| Flight Procedures Cover Page | Task Action: FLIGHT CHECK | Task Type: IAP | Estimated Chart Date: 07/09/2026 | APWS Task ID: EB02F8D447B543A49C86447897DA1E7E | APWS Project ID: 217EA7C492F1453D959F4C9FD8D8017F |
| Procedure: RNAV (GPS) RWY 6 AMDT 2 | | Enroute: NO | Specialist: Denton, Hope | | Agreement Number: |
| Airport ID: KIKW | | | Airport City: MIDLAND | | State: MI |

Subject: **ACTION:** Approval Request, Jack Barstow, Midland, MI (KIKW), RNAV (GPS) RWY 6

RNAV (GPS) RWY 6

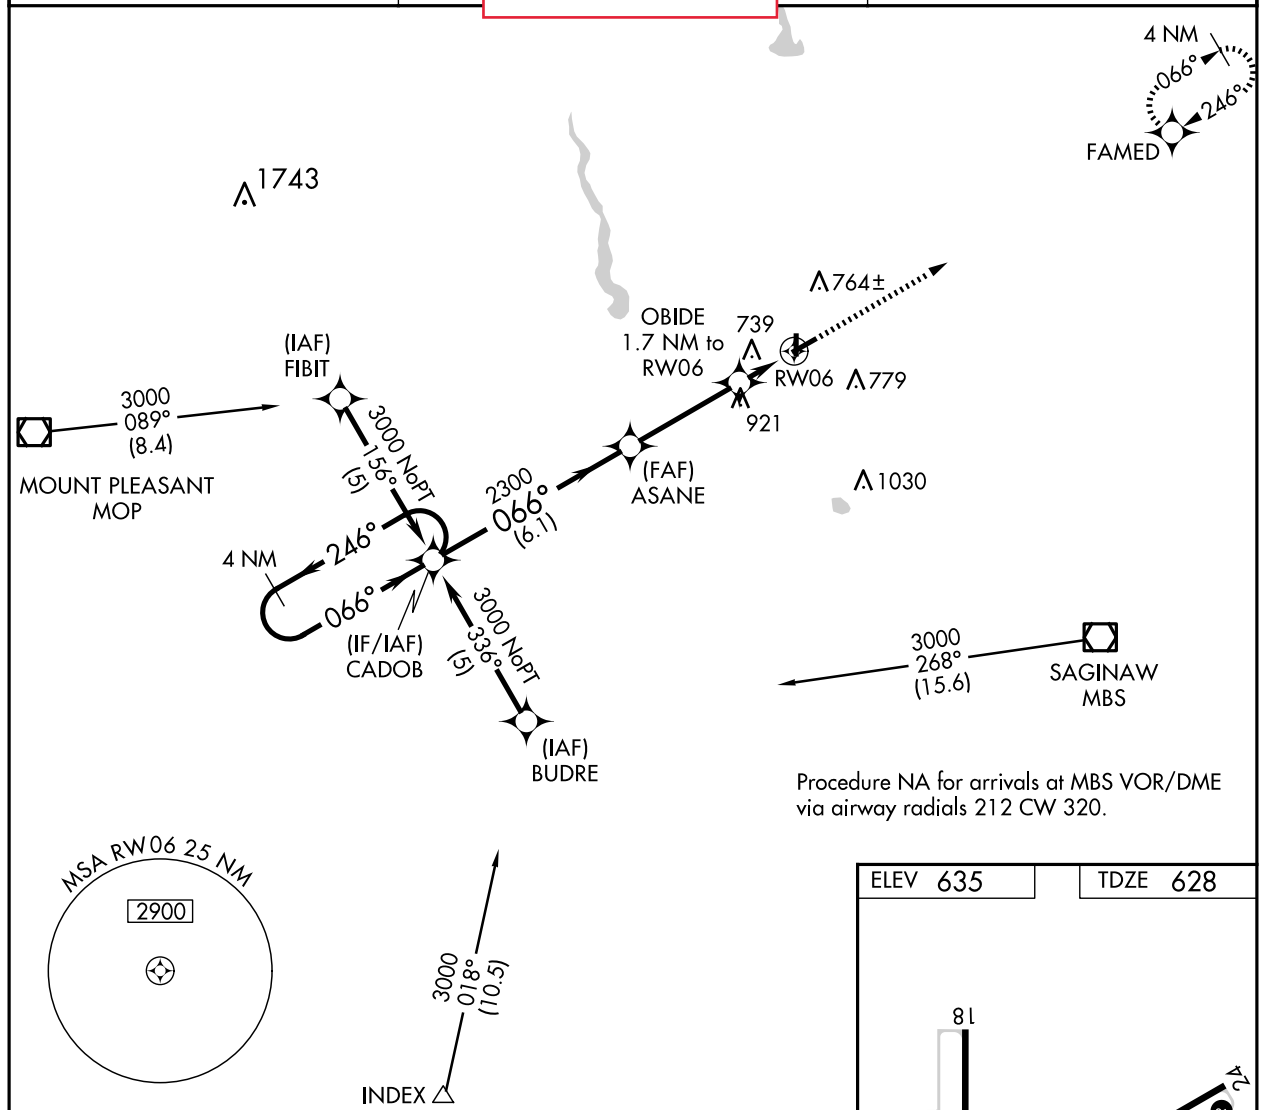
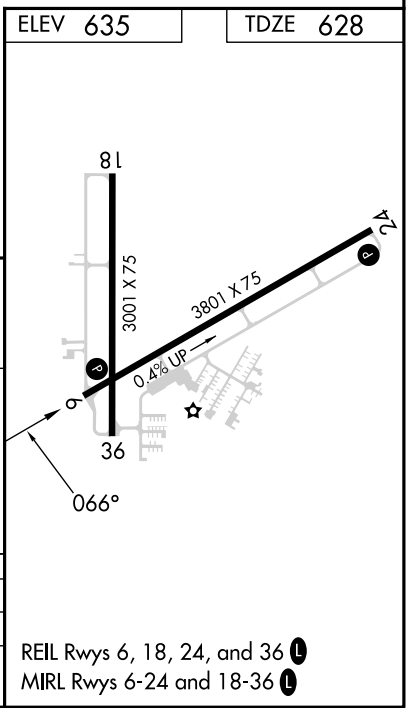
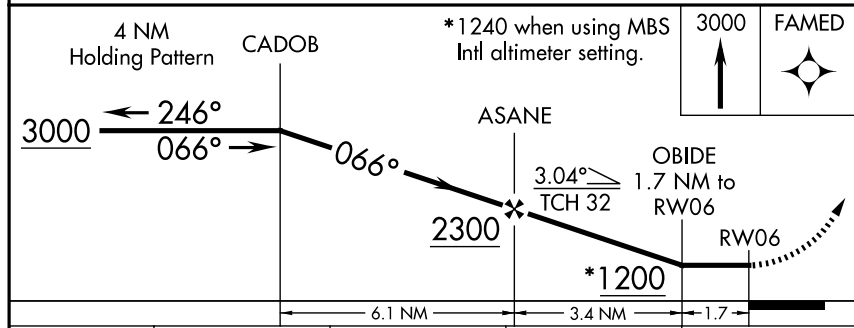
Glidepath Angle (GPA) and Vertical Descent Angle (VDA). FAAO 8260.3F, para 2-6-2a. Approval is required to establish a GPA or a VDA (of a procedure where the FAC is straight-in aligned) that is more than 0.20 degrees greater than the glidepath angle of a visual glide slope indicator (VGSI) installed on the same runway.

The currently published RNAV (GPS) RWY 6 procedure was built with a Final Angle/TCH of 3.04/32 and has been flown without issue. Request to raise the currently published VDA to 3.25/32 in order to mitigate obstacles and maintain the published CAT A, B, and C minimums. The airport is planning a future study to allow for the mitigation of the non-coincident note by bringing the VDA/Glidepath Angle and Visual Glideslope within acceptable range. This process is expected to be accomplished within the next 3 years. If approval is not granted, the airport may not have this as a usable procedure, and relocating the VGSI at this time is not possible because of costs associated.

Will utilize CHART PROFILE NOTE: VGSI AND DESCENT ANGLES NOT COINCIDENT (VGSI ANGLE {ANGLE}/TCH {FEET}) per 8260.19J para 8-6-9m(1).
